DOCUMENT 00 9010
ADDENDUM NUMBER 01

DATE: **October 6,2022**
PROJECT: SE Branch Library Parking Lot Replacement
PROJECT NUMBER: PJ000106
OWNER: City of Arlington
ARCHITECT: Simon Engineering & Consulting, Inc.
 15443 Knox Trail Drive, Suite 140
 Dallas, TX
 Ph: (214) 884-2056
TO: Prospective Bidders

**CITY OF ARLINGTON
SE BRANCH LIBRARY PARKING LOT REPLACEMENT
QUANTITY SUMMARY**

CITY OF ARLINGTON, TEXAS
 ARLINGTON PUBLIC LIBRARY SOUTHEAST BRANCH
REMOVAL PLAN
 900 SE GREEN OAKS BLVD, ARLINGTON, TX 76018

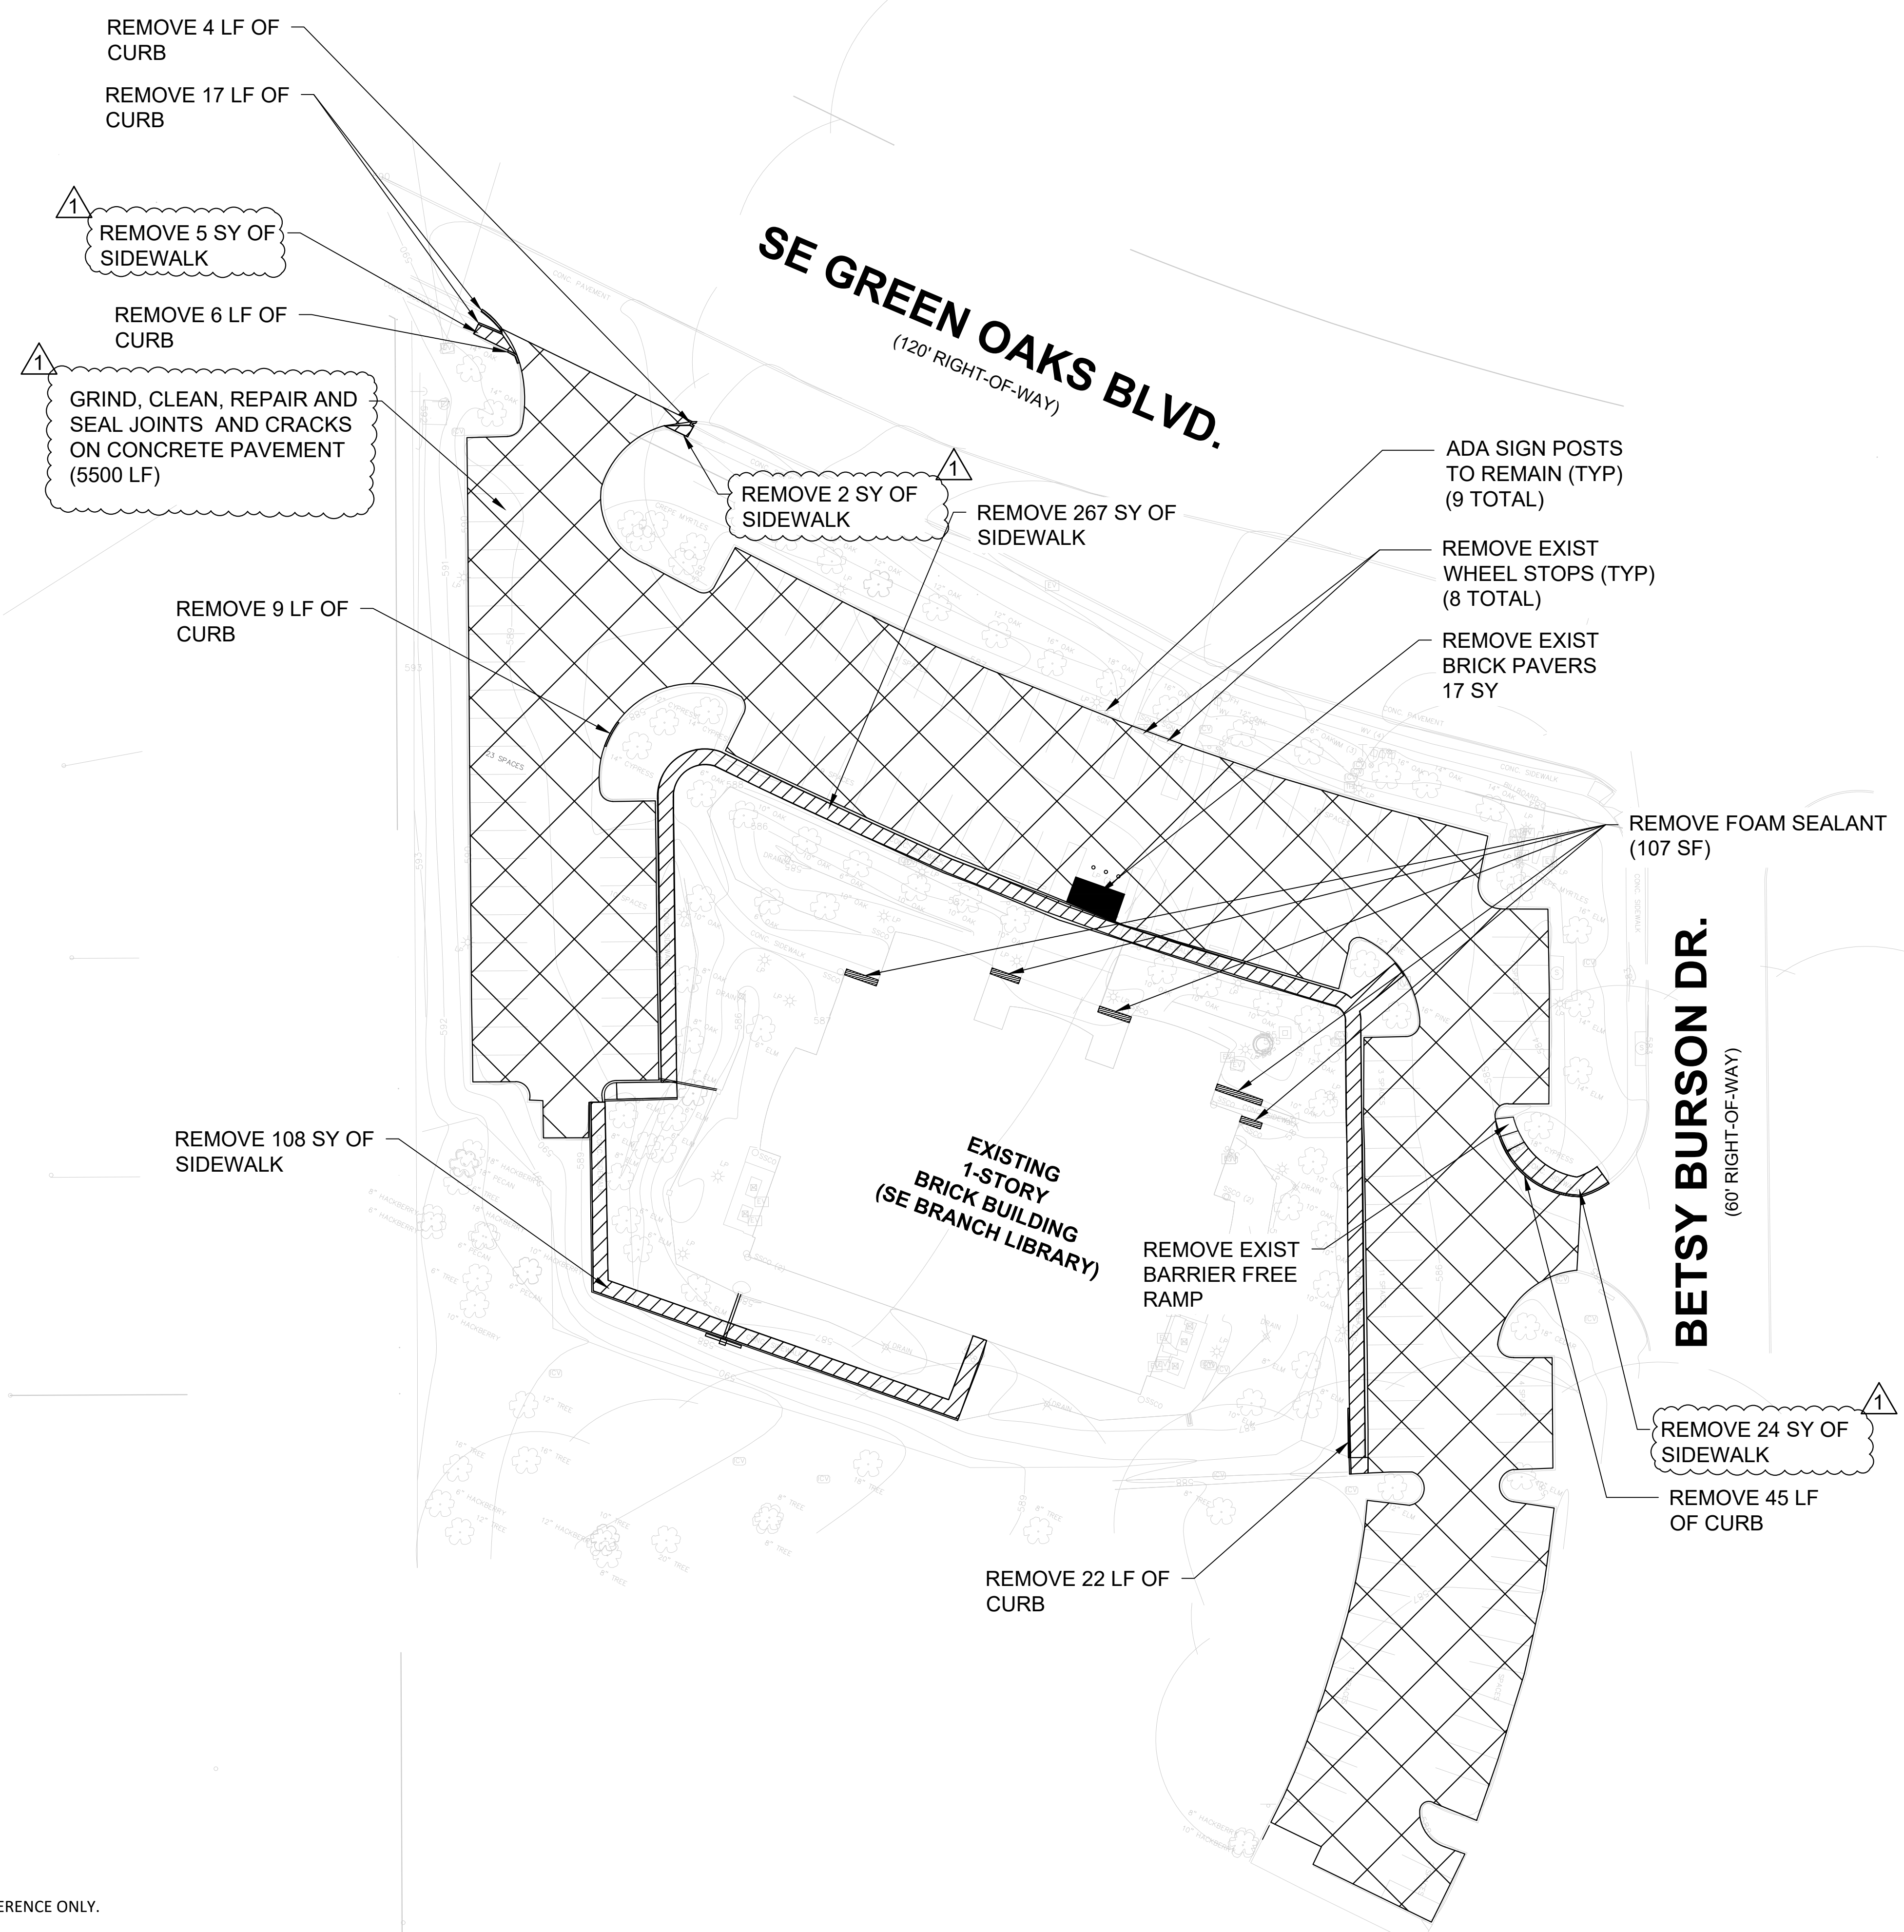
| No. | Date | Revisions |
|-----|------------|---------------------------------|
| 1 | 10/05/2022 | PVMT TREAT REVISED/SDWK REVISED |

CITY OF ARLINGTON, TEXAS
ARLINGTON PUBLIC LIBRARY SOUTHEAST BRANCH
CONSTRUCTION PHASING PLAN
900 SE GREEN OAKS BLVD, ARLINGTON, TX 76018

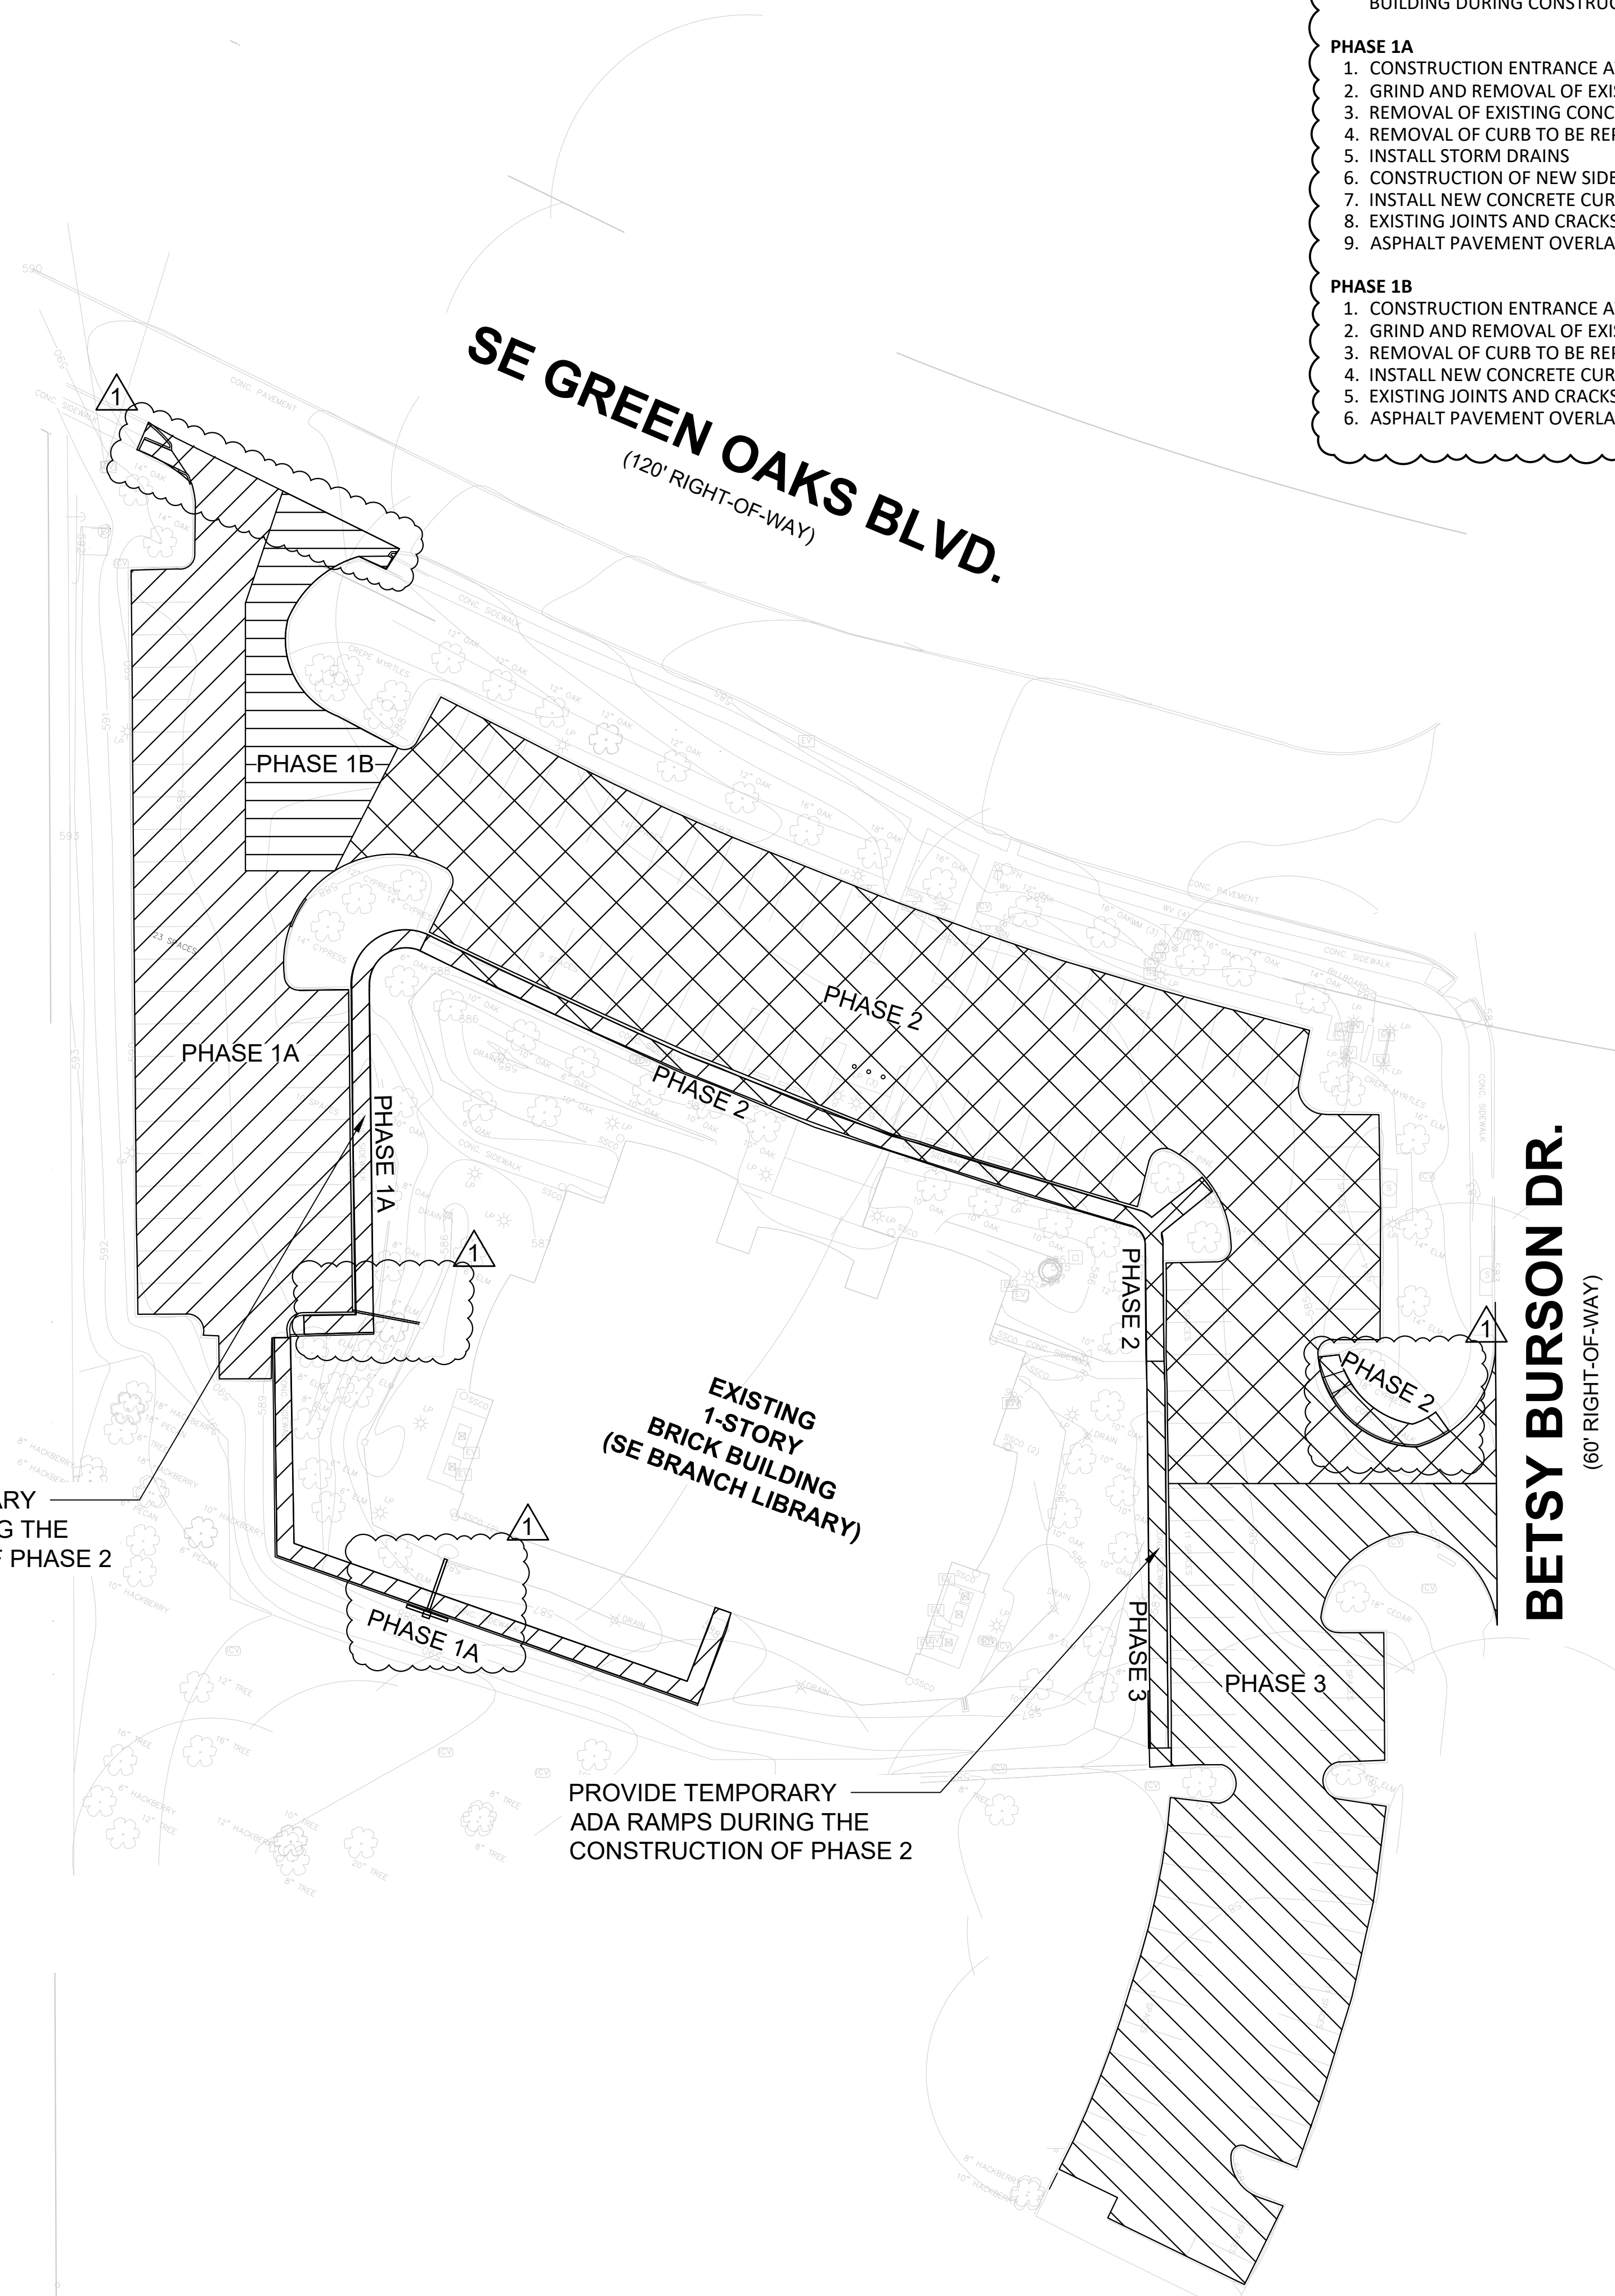
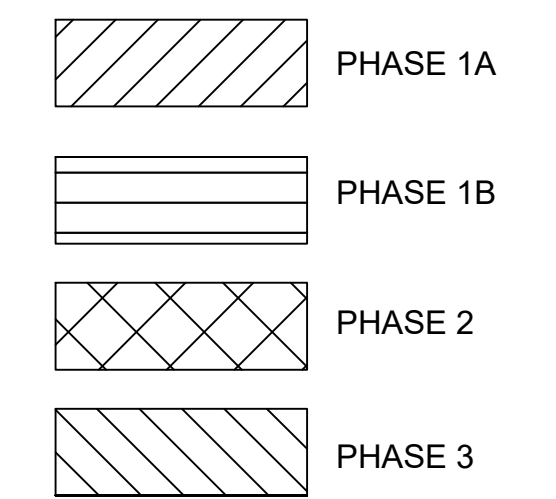
| No. | Date | Revisions |
|-----|------------|----------------------------|
| 1 | 10/05/2022 | PHASING PLAN/NOTES REVISED |
